METROPOLITAN GOVERNMENT OF NASHVILLE AND DAVIDSON COUNTY

STAFF RECOMMENDATION
3618 Westbrook Avenue
May 15, 2013

Application: New Construction—Addition
District: Richland-West End Neighborhood Conservation Zoning Overlay
Council District: 24
Map and Parcel Number: 10405021900
Applicant: James Lowen
Project Lead: Melissa Baldock, melissa.baldock@nashville.gov

Figure 4. The carport will help to reduce the visual impact of the attached garage.

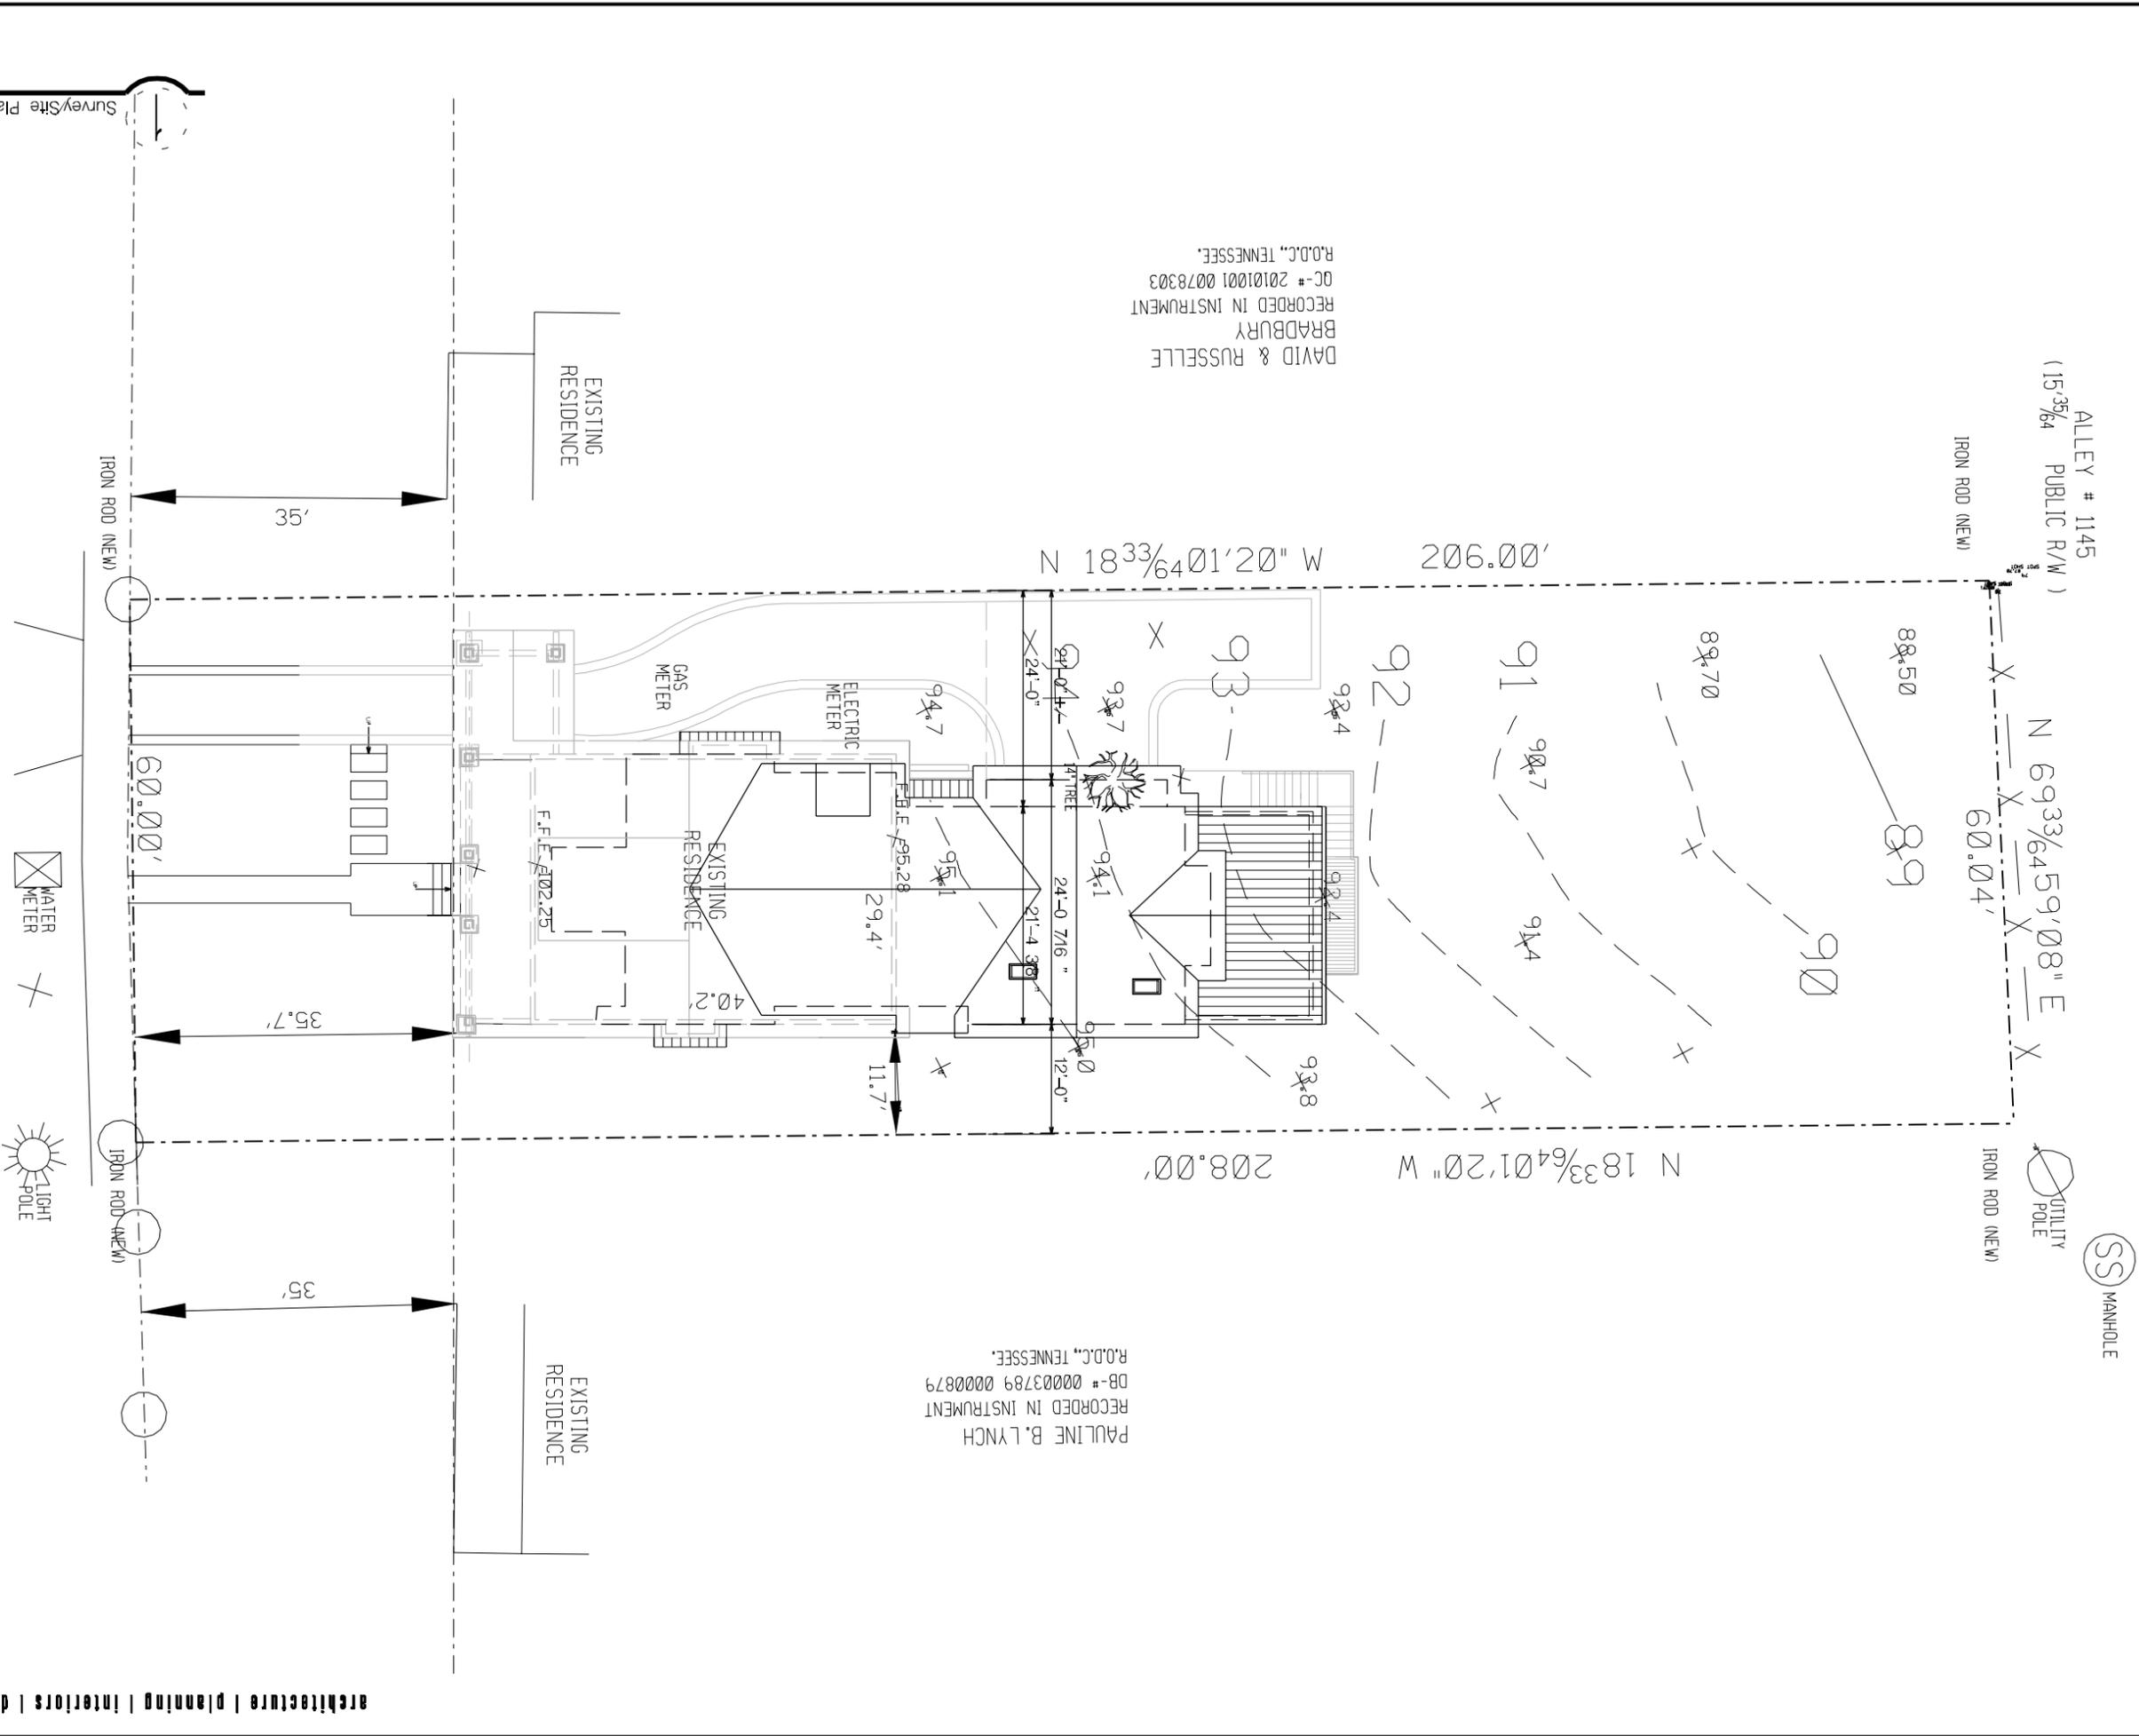
Outbuilding: An attached garage is proposed for the left side of the addition. The design guidelines state that attached garages can be appropriate when “*the location of the attached garage is in the general location of an historic accessory building, the new garage is located in the basement level, and the vehicular access is on the rear elevation.*” In this instance, the garage is located at the basement level and is located towards the rear of the house, where an accessory structure would have typically been located. However, the vehicular access is on the side façade, not the rear. Staff finds this to be appropriate because the garage doors will be inset six feet (6') from the back wall of the house. The upper floors which cantilever over the garage and the historic carport at the front of the house will both further obscure the visual impact of the attached garage on the historic house (see Figure 4). Staff finds that the attached garage meets section II.B.1.h. of the *Richland-West End Neighborhood Conservation District: Handbook and Design Guidelines*.

Basement Level Floor
Plan

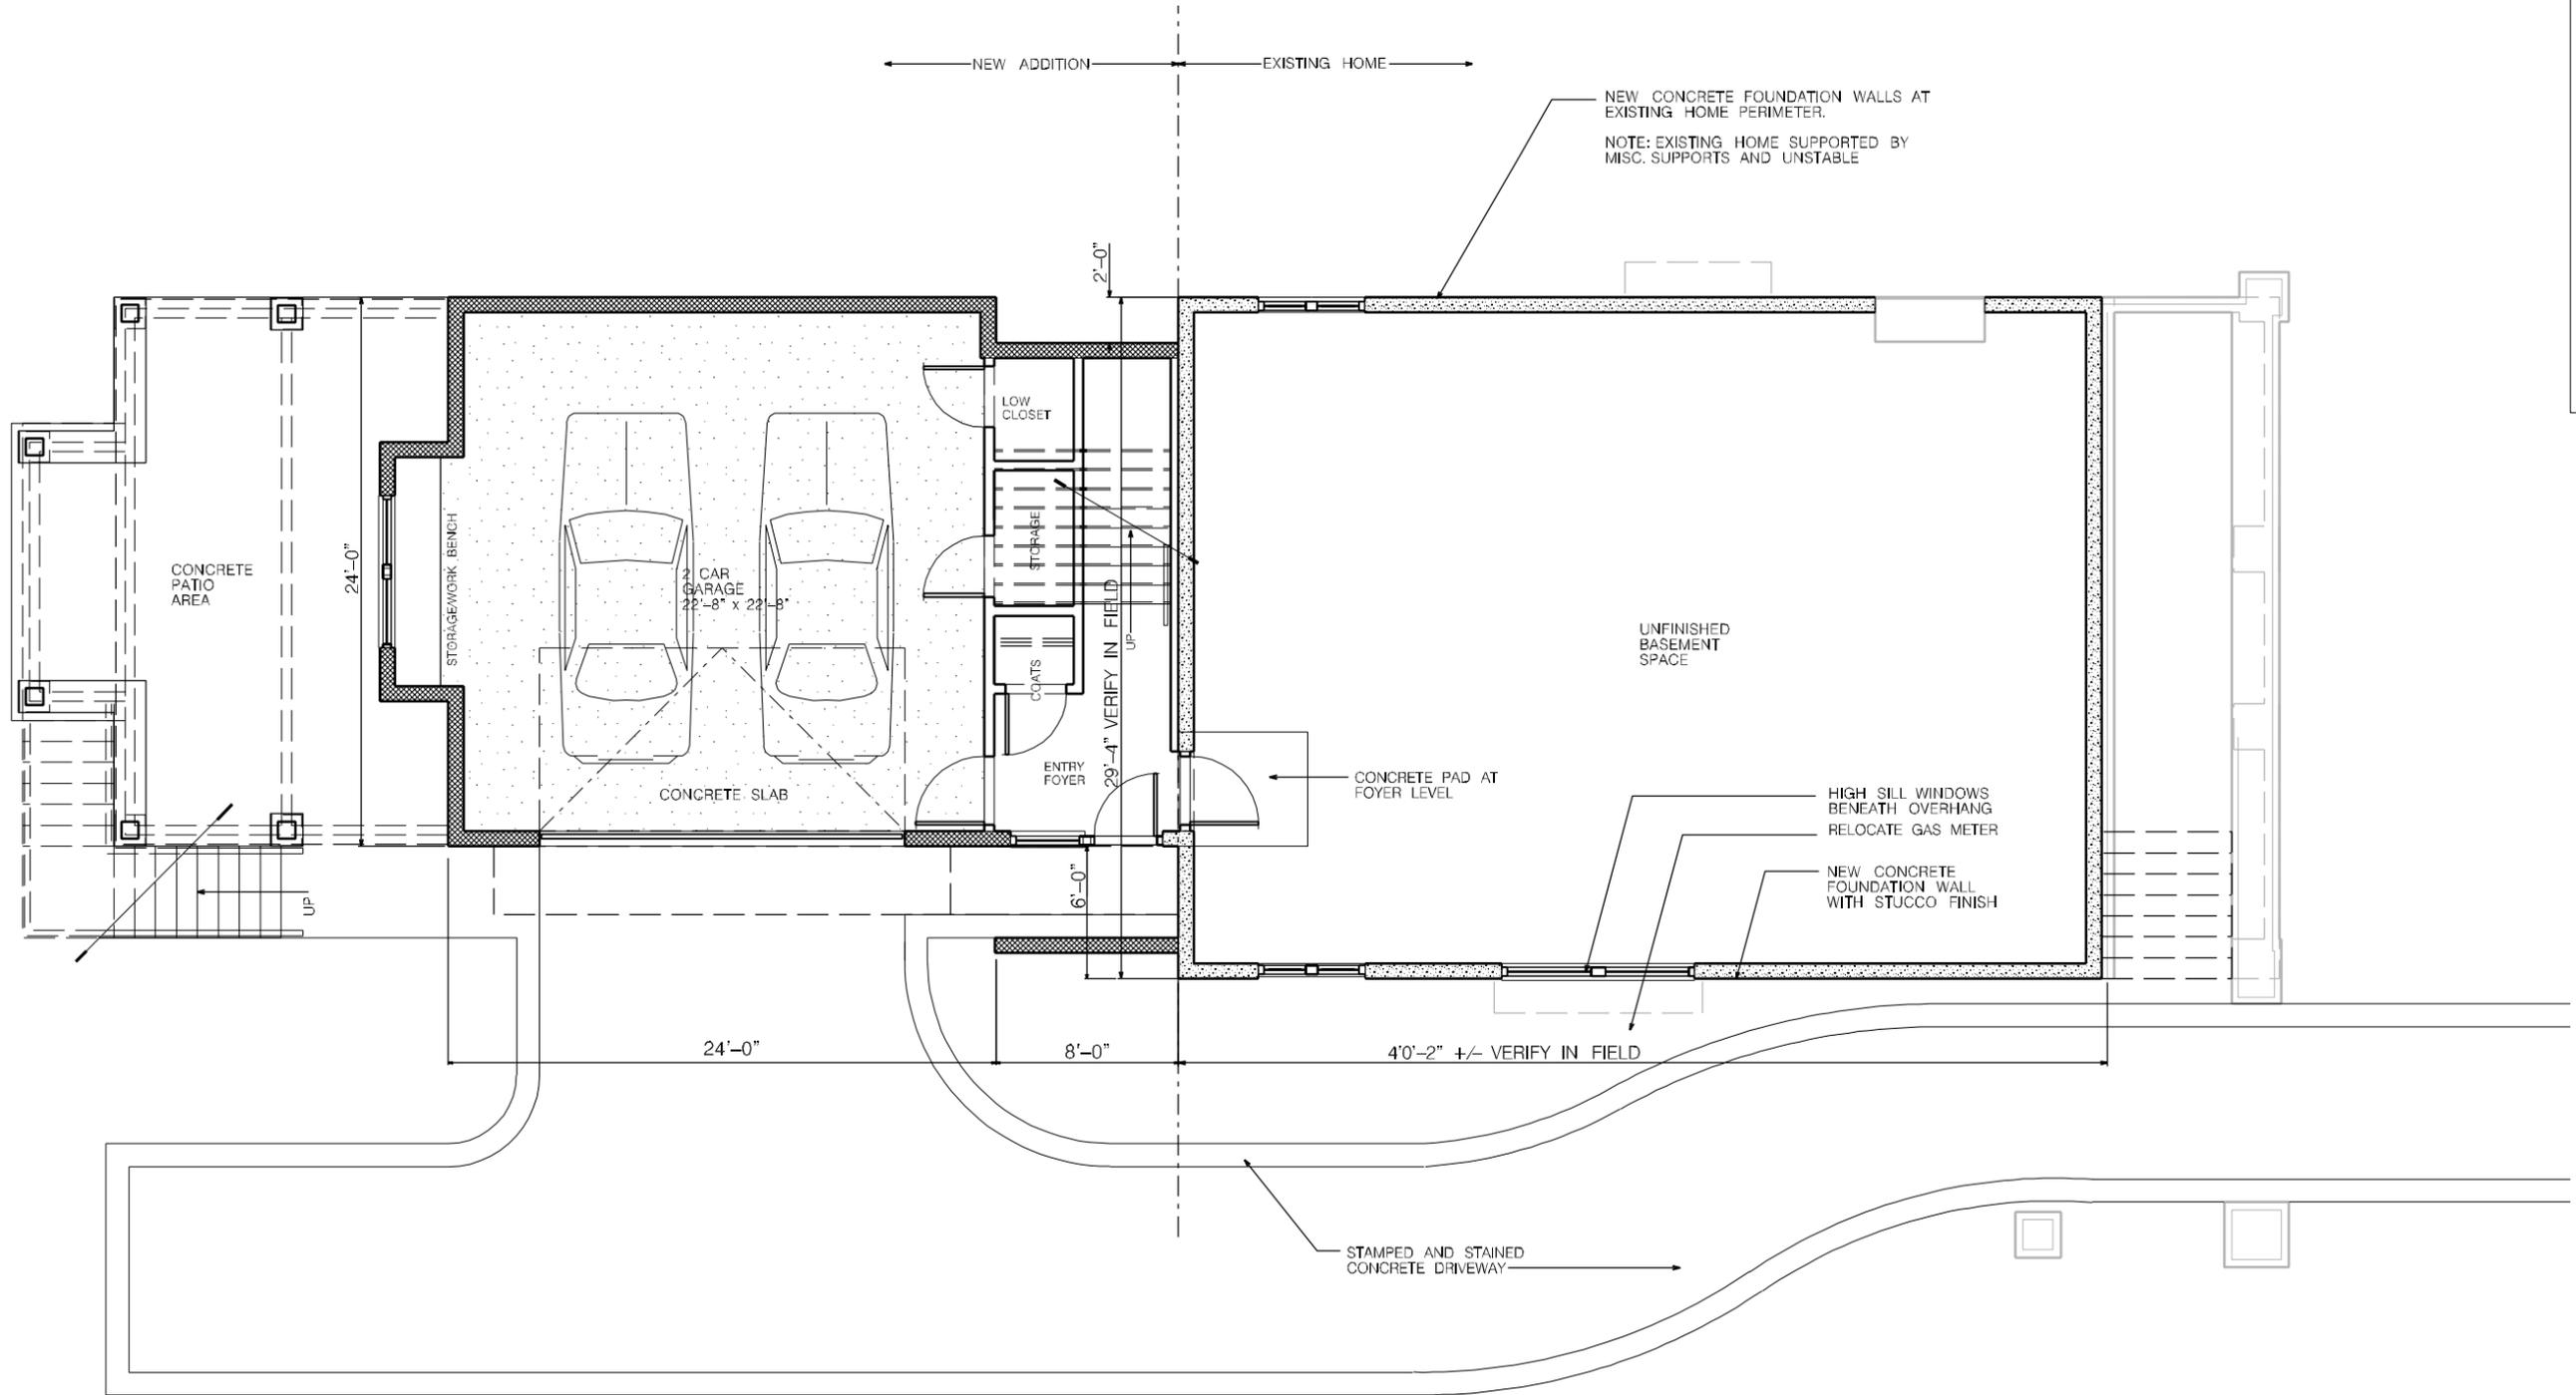
The basement level of the house, where a garage will be located, continues for the remaining depth with the six foot (6') inset, while the first and second stories come back out to match the side wall of the house. The addition has a maximum width of approximately twenty-six feet, six inches (26'6") and a maximum depth of approximately fifty feet (50'). The addition has a foot print of approximately one thousand, one hundred and seventy-five square feet (1,175 sq. ft.). Staff finds that the addition's scale is appropriate to the house and to the district, particularly since the structure sits on a lot that is over twelve thousand square feet (12,000 sq. ft.).

1. The applicant submit revised elevations that indicate how the window openings on the existing house will be altered.
2. The concrete foundation wall on the house have a parge coat and the foundation on the addition either be split-face concrete block or smooth face block with a parge coat.
3. Staff review and approve the shingle and metal roof color, brick samples, and all window and door specifications.
